AUTORIDAD DEL CANAL DE PANAMA  
Division de Proyectos de Capacidad del Canal

**Work Order No. 6  
Reservoir Water Quality Model  
For Three Proposed Reservoirs in Panama  
Contract No. 20075 [CC-3-536]**

**Preliminary Assessment  
of the  
Water Quality Data Collection Program**

Figure 2: Routine water quality sampling locations.

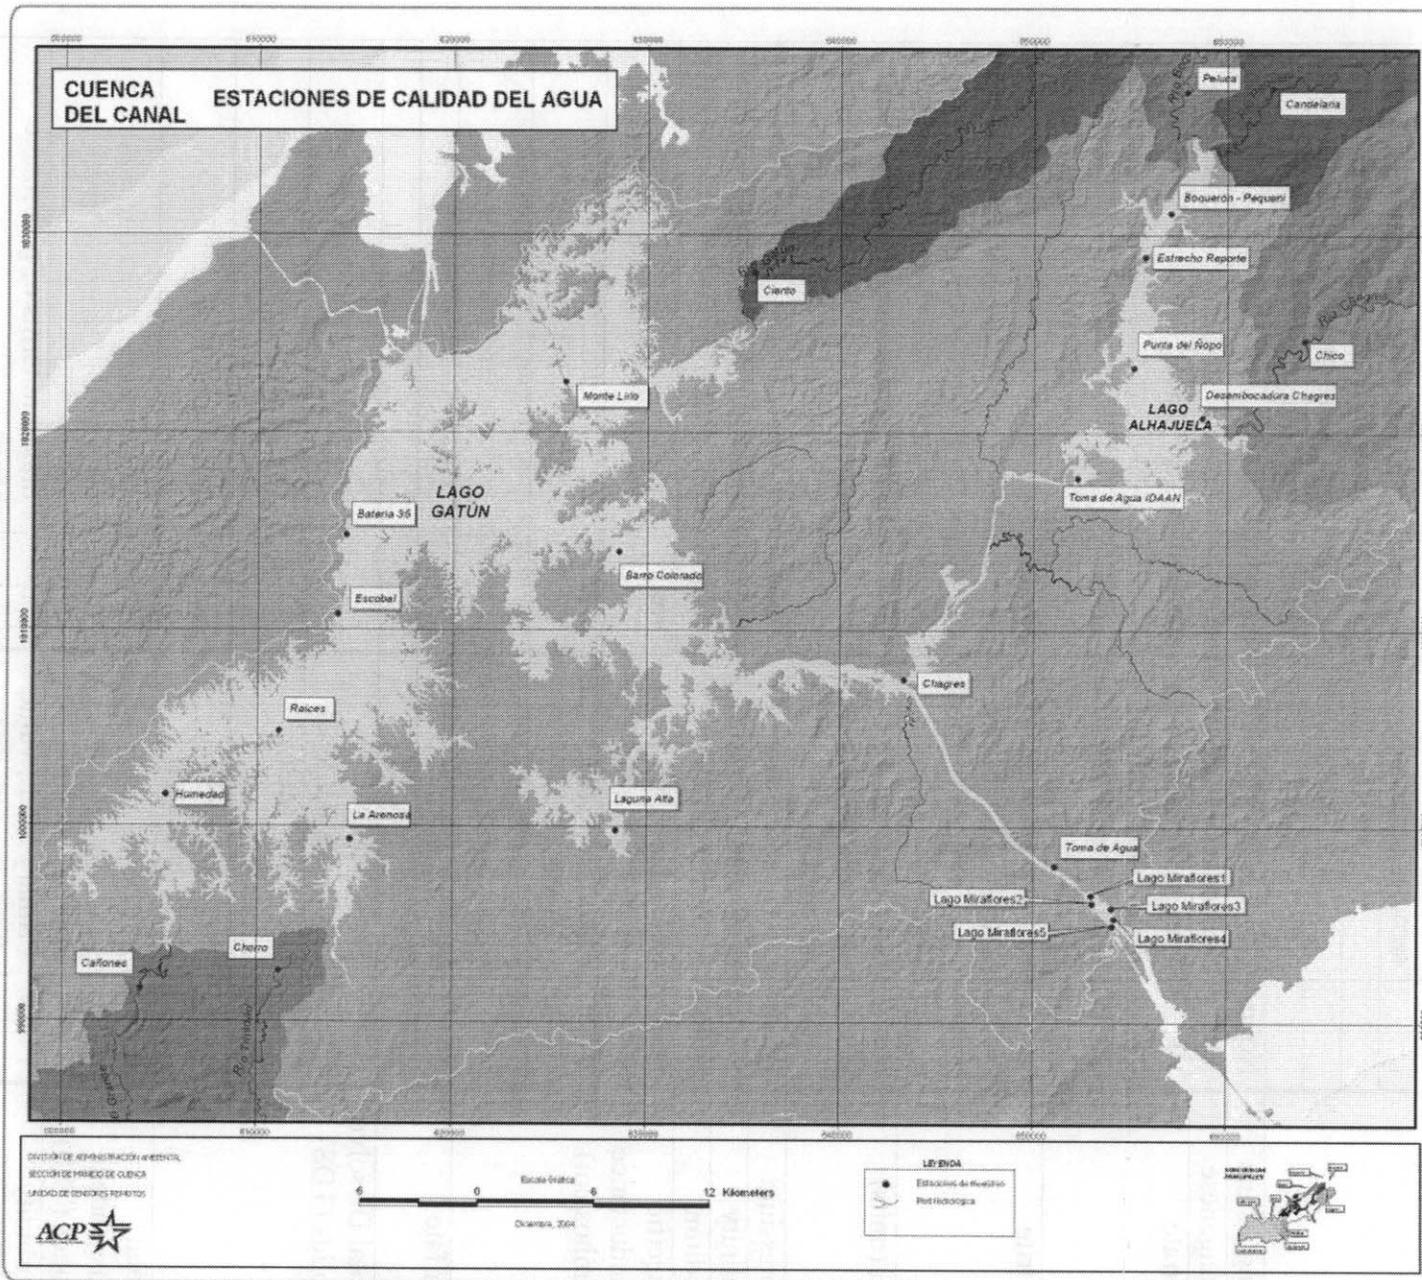
ACP generally collects reservoir samples around the edges of the reservoirs. To support additional modeling, we recommend adding locations in the deepest portions and/or mid-sections (lateral) of each reservoir, such as near the dams and in the navigation channels. These additional locations should include Hydrolab measurements at 1-meter intervals. At a minimum, these measurements should include temperature, turbidity and dissolved oxygen. We also recommend establishing locations upstream of the locks on both the Pacific and Atlantic side to monitor salinity intrusion. At a minimum, one location near the locks and one location sufficiently distant that salinities are less than 0.1 ppt should be selected. The latter location will provide valuable baseline data for salinity intrusion and will provide the first warning if salinity levels are increasing. In addition, it would be useful to have a station intermediate between these two stations. Locations should be established downstream as well, in order to determine if downstream/ocean salinities vary (for example salinity may vary with wet/dry season).

Figure 2. Conductivity in Gatun Lake.

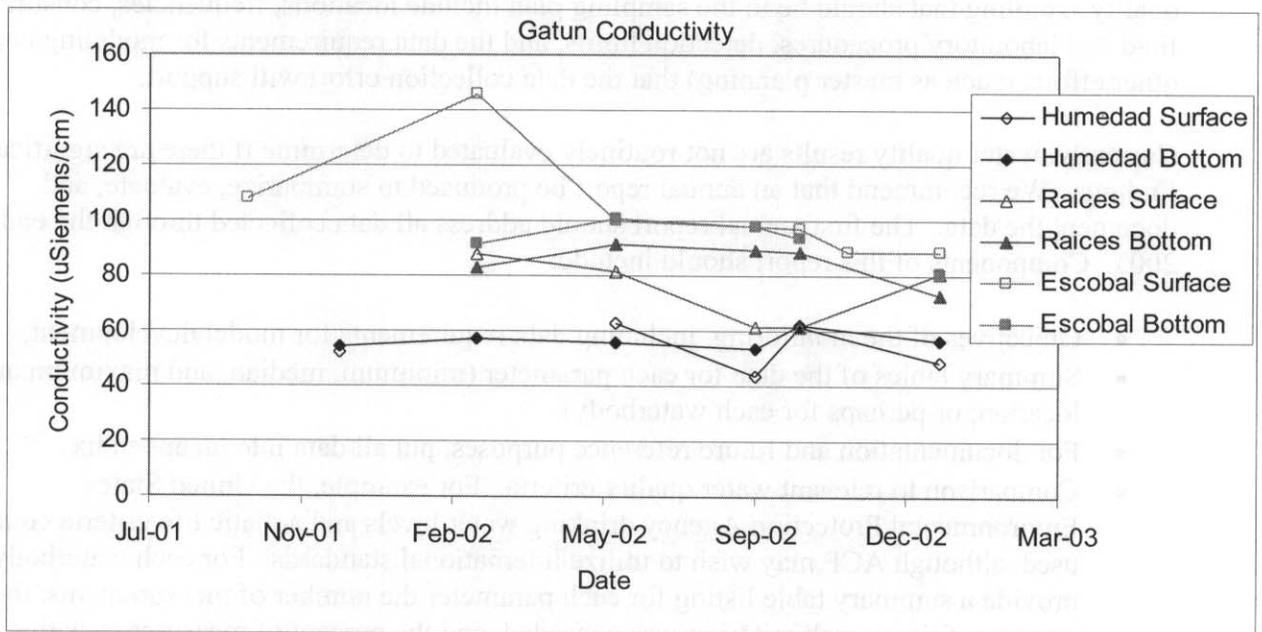
These types of plots are important, because they enable visualization of trends and comparisons that are often not apparent in tabular data. When producing these plots, as much as possible, use a consistent system to denote locations/depths, and use the same scale, so that plots can be compared to one another. Another detail to watch is to use color, but to use it in such a way that if the images are converted to black and white it is still usable. Different types of dashed lines may be used. An example plot using Water Quality Unit data is provided below (Figure 2). Note that in this example open symbols represent surface locations and solid symbols depth locations. From this plot it can easily be observed that Escobal has the highest conductivity (salinity), and that while surface conductivity is generally less than depth conductivity at Escobal, the reverse is true at Raices.
